CITY OF ALBUQUERQUE

**RE: Winrock Town Center
Conceptual Grading & Drainage Plan
Engineer's Stamp Date: 6/17/25
Hydrology File: J19D058L
Case # HYDR-2025-00220**

CONCEPTUAL GRADING & DRAINAGE PLAN

TITLE: CONCEPTUAL GRADING PLAN

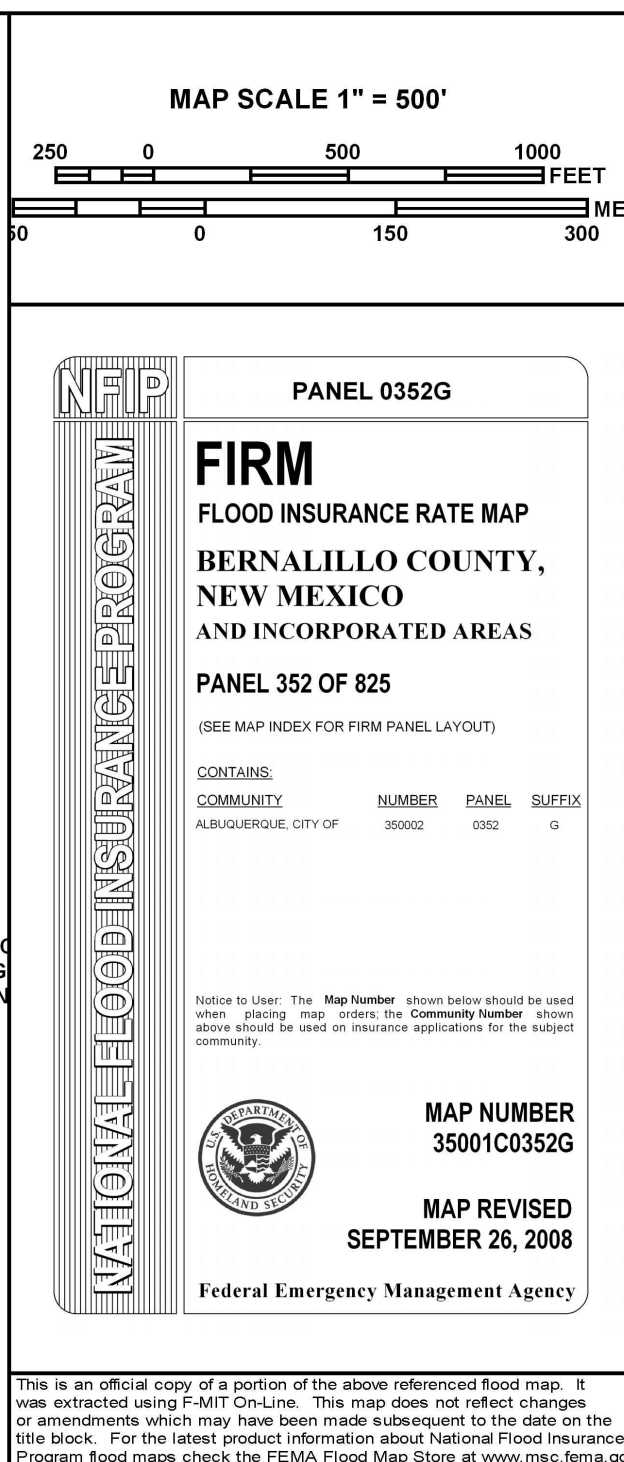
Based upon the information provided in your submittal received 06/18/2025, the Conceptual Grading & Drainage Plan is preliminary approved for action by the Development Facilitation Team (DFT) on Site Plan for Building Permit and for action by the Development Hearing Officer (DHO) on platting.

1. Please submit a more detailed Grading & Drainage Plan to Hydrology for review and approval. This digital (.pdf) is emailed to PLNDRS@cabq.gov along with the Drainage Transportation Information Sheet.
